ORIGINATION FORM

Proposed Revisions to a Standard Plans Index
(Please provide all information — Incomplete forms will be returned)

Index Number: 509-070

Index Title: Railroad Grade Crossing Traffic Control Devices

RELATIVE LOCATION OF CROSSING TRAFFIC CONTROL DEVICES

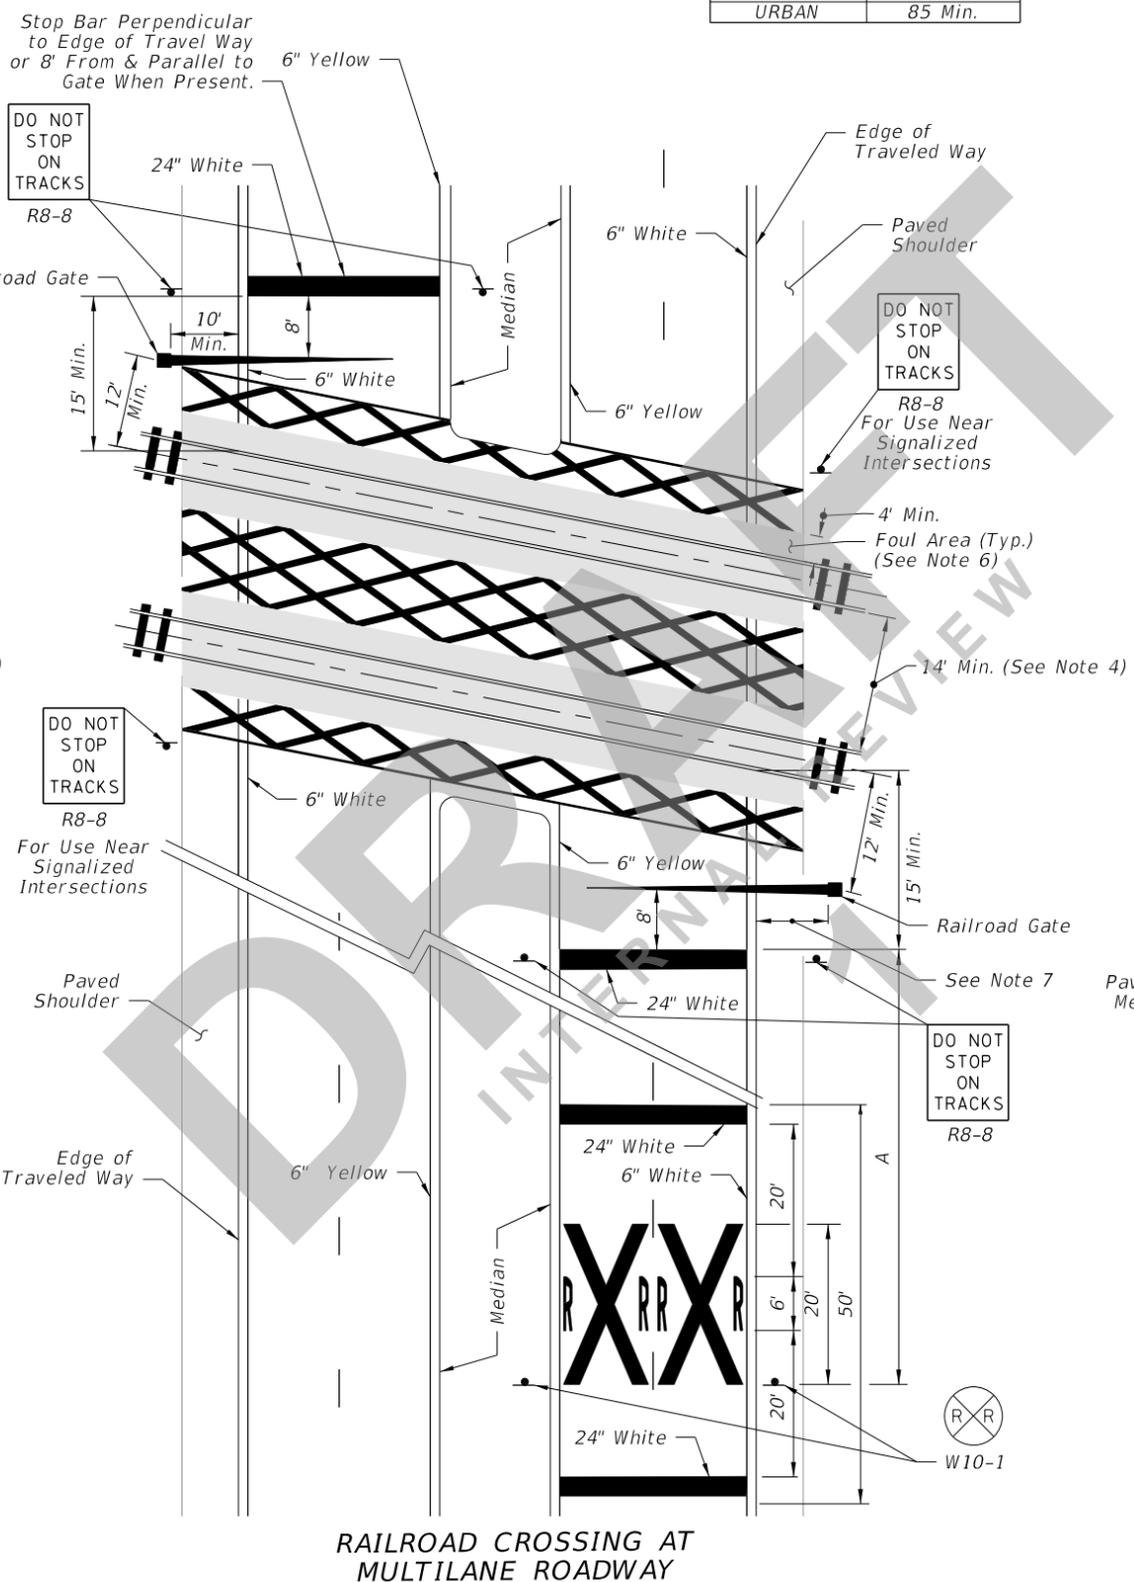
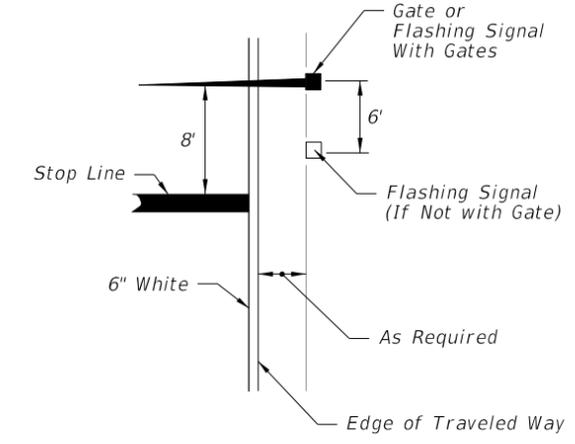
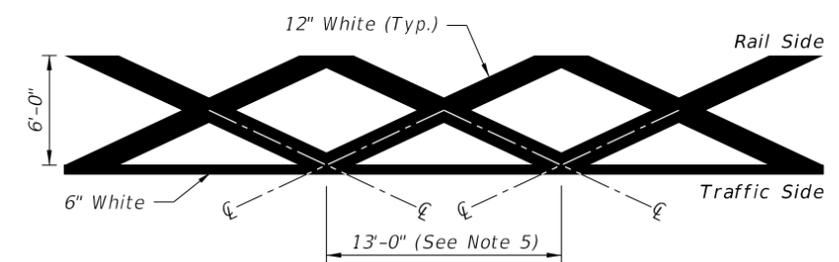
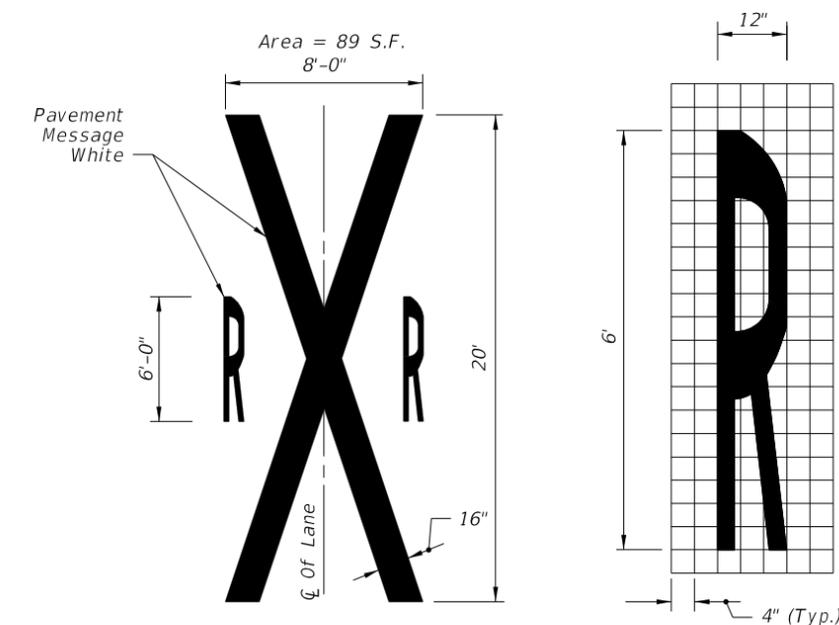
Removed railroad gate dimension from Sheet 3 and add a note that references Sheet 1 and 2.

Change was requested by D2 rail office. Sheet 3 has a minimum distance of 10' labeled to the Railroad Gate. This label should be removed from sheet 3 of 4. This distance is different for flush shoulders versus curb roadways. These distances are clearly detailed on sheets 1 of 4 and 2 of 4 for the various traffic control devices.

1. Place an additional W10-1 sign where intersections occur between the R/R pavement message and the tracks.
2. Place FTP-61-06 or FTP-62-06 sign 100' in advance of crossing for urban conditions and 300' in advance of crossing for rural conditions. See Index 700-102 for sign details.
3. Install Railroad Dynamic Envelope Pavement Markings only when called for in the Plans.
4. Do not install pavement markings when the distance between tracks is less than 14'.
5. The transverse dimension for the RDE "X" may be reduced to the lane width for two-lane roadways without shoulders or when shown in the Plans.
6. Do not install pavement markings in the Foul areas.
7. See Sheets 1 and 2 for dimension.
